ADDENDUM NO. 1

September 11, 2017

RE: Robertson County Solid Waste/
Recycling Convenience Center
Cedar Hill, TN
HFR Project No. 2016172

UTILITY PLAN

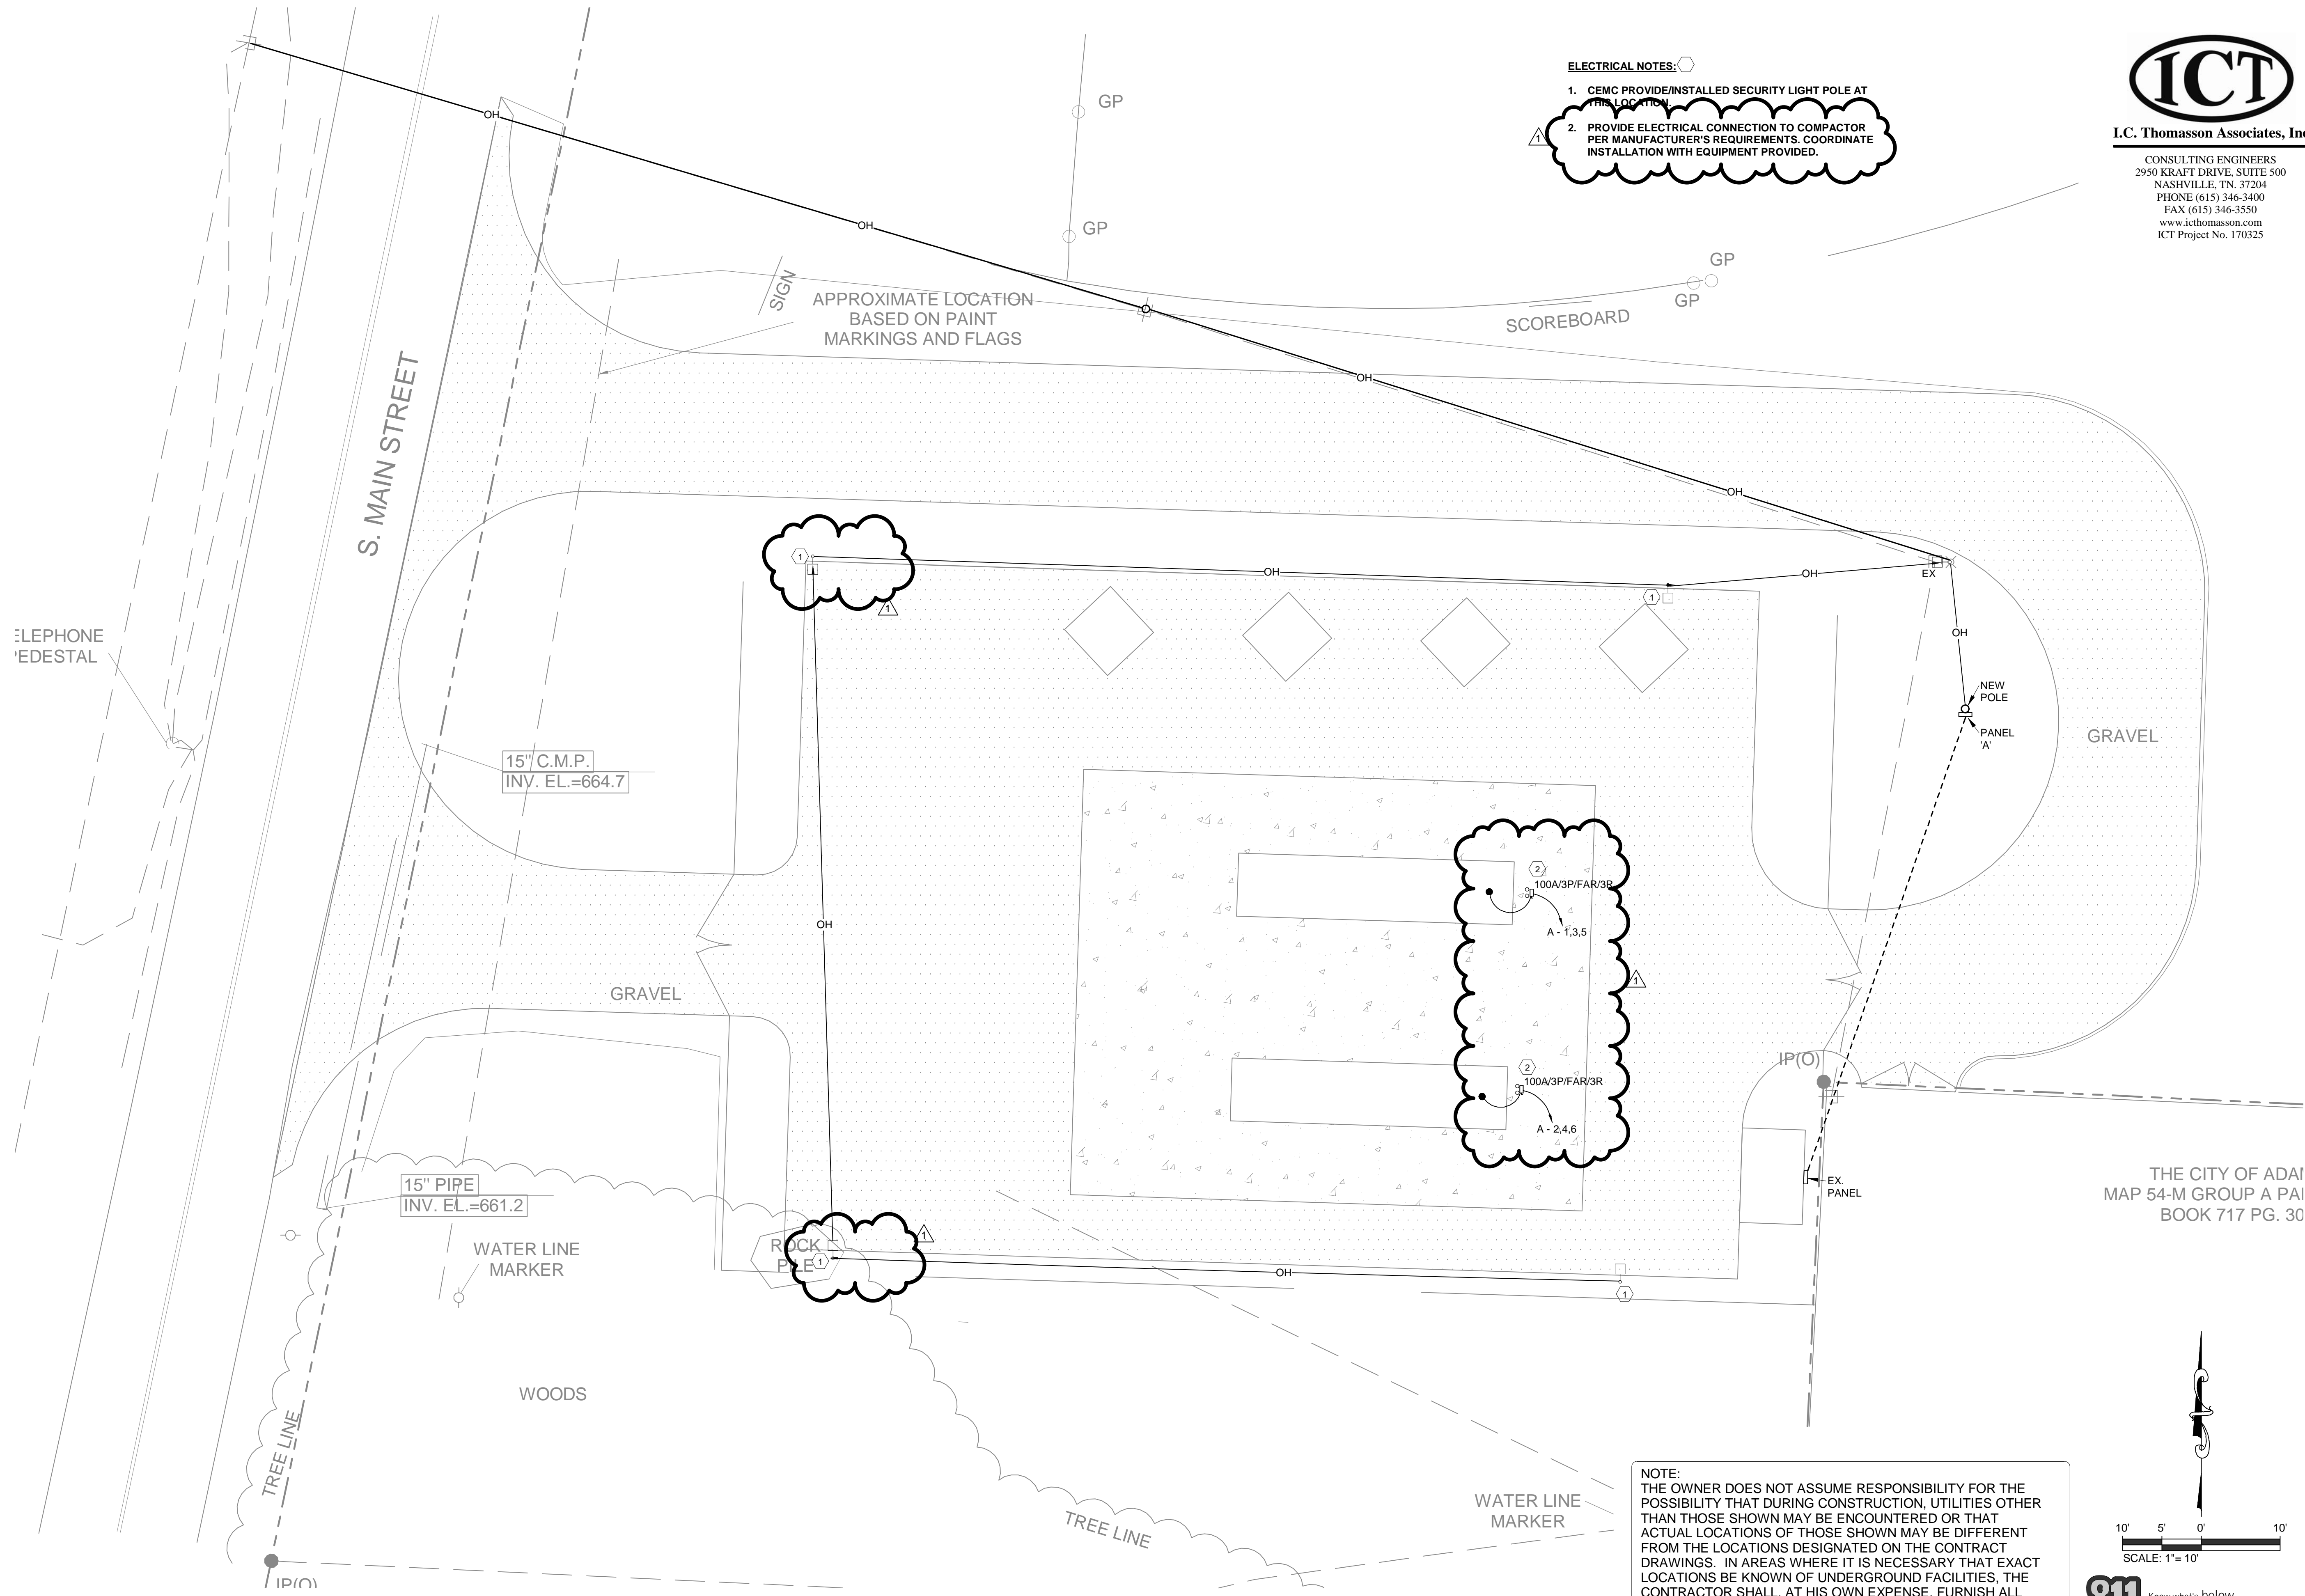
- 1-4 DRAWING C1.01 – SITE PLAN: Add the following note to the Sheet:
“The anchors securing the steel plate to the concrete shall be ½” diameter, placed at a minimum 4’-0” on center and within 4” of the ends and sides. The exposed surface of the steel plate shall not have exposed bolts or fasteners that would prevent the compactor being rolled into place.”
- 1-5 DRAWING C4.01 – Utility Plan: Revise the location of the water meter and tap per the revised plan. Delete the drawing as originally issued and replace with the attached.
